## MEMORANDUM

**SUBJECT:** BZA Case No.18184                      1421 Florida Avenue, NW

**Figure 2. Natural and finished grade illustration.** (The pattern indicates all of the area the applicant would not count toward FAR using the natural grade method. The pink areas would be the addition GFA counted toward FAR using the finished grade method).

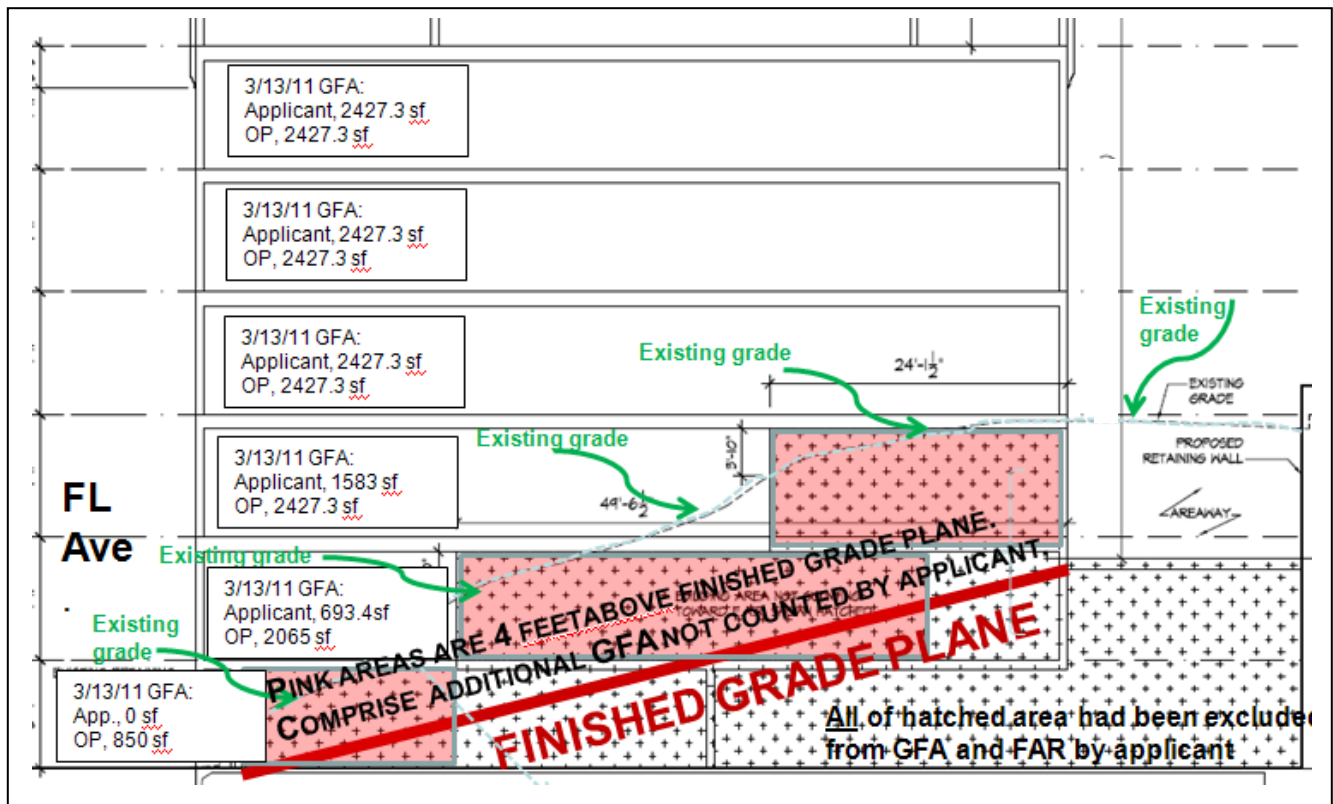
The applicant’s gross floor area and FAR calculations are of concern. The applicant has used the natural grade – i.e., the hill that now rises twenty-five feet between the front and the back of the building – to calculate the gross floor area FAR. The Zoning Administrator, when consulted by OP about this application, has stated that 11 DCMR §199’s definition of Gross Floor Area requires that he use the finished grade of the building- i.e., what is projected as the post-excitation grade – to calculate FAR. The differences between the two methods are illustrated in Figure 2, below. While the natural grade method yields a projected 9,558.3 GFA and 2.3FAR (6.5% greater than matter of right with IZ), the finished grade method yields an approximately 12,624 GFA and 3.05 FAR (approximately 41% greater than matter of right with IZ) /

The Board stated in *BZA Case 17109, Findings of Fact 36, FAR Calculations*, “Under the ‘grade plane’ method, a plane is established between the grade at the front of the building and the grade at the rear of the building. The point at which this plane intersects at a four foot level, any portion that exceeds that plane counts toward FAR and any portion that does not is considered a cellar”. The Zoning Regulations’ definition of Gross Floor Area stipulates that “Cellar area is not included in

FAR” and that a cellar is “that portion of a story, the ceiling of which is less than four feet above the adjacent finished grade. Granting FAR relief based on a natural grade plane would cause substantial harm to the zoning regulations.
